New functions and addendum

- This document contains descriptions of how to set the new functions and their restrictions. Refer also to the Operating Instructions of this product.
- Depending on the model used, the screens shown in the explanations may differ to the actual camera screens.
- This document is for the following models.
 WV-S2500 Series (WV-S2536LN, WV-S2536LTN, and WV-S2536L),
 WV-S2200 Series (WV-S2236L),
 WV-S2100 Series (WV-S2136L and WV-S2136),
 WV-S1500 Series (WV-S1536LN, WV-S1536LTN, and WV-S1536L),
 and WV-S1100 Series (WV-S1136).

Due to software upgrade, the following functions have been added and changed to this product.

6. Change AI-VMD and AI People Detection to be pre-installed

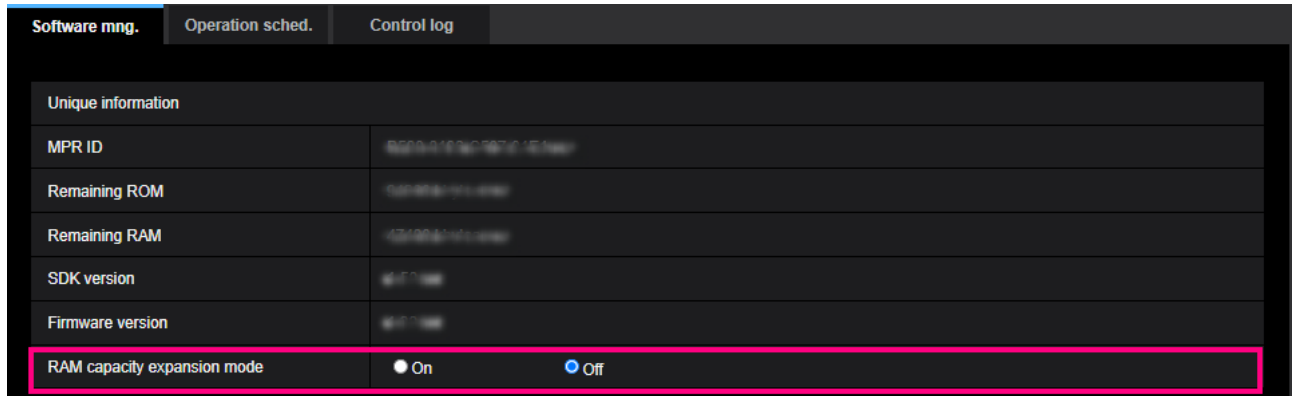
Change the pre-installed Ext. software AI Video Motion Detection (“AI-VMD”) and AI Privacy Guard to AI-VMD and AI People Detection. Along with that, it is stated in "Note" that AI-VMD and AI People Detection are pre-installed.

- AI-VMD and AI People Detection are already installed. For further information, refer to the respective operating instructions.
- The camera software upgrade will not change the installed Ext. software.

7. Add RAM capacity expansion mode

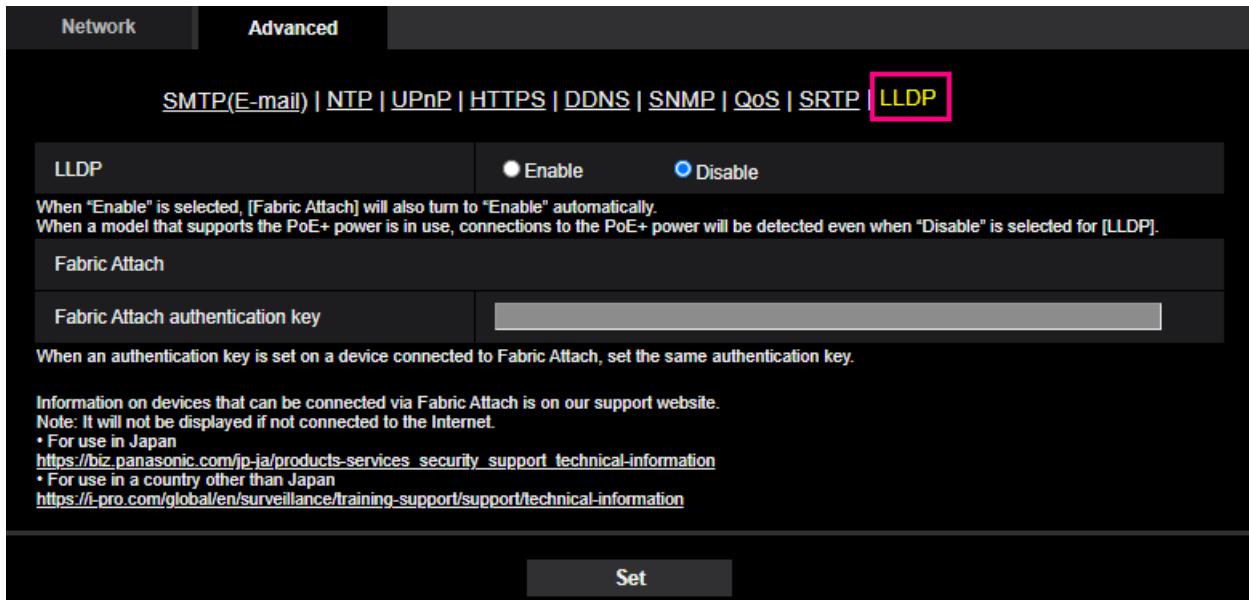
RAM capacity expansion mode has been added to the software management screen.

This mode increases the amount of RAM available to the Ext. software.

- When “RAM capacity expansion mode” is set to “On”, the recording function to SD memory card by this product cannot be used.
- If the minus is displayed in the “Remaining RAM” value, uninstall the ext. software or set the remaining RAM to “On”.
- Click the [Set] button to restart the product. After restarting, the product cannot be operated for about 2 minutes, same way as when the power is turned on.
- For information about the Ext. software that requires the “RAM capacity expansion mode” to be set to “On”, refer to our support website.
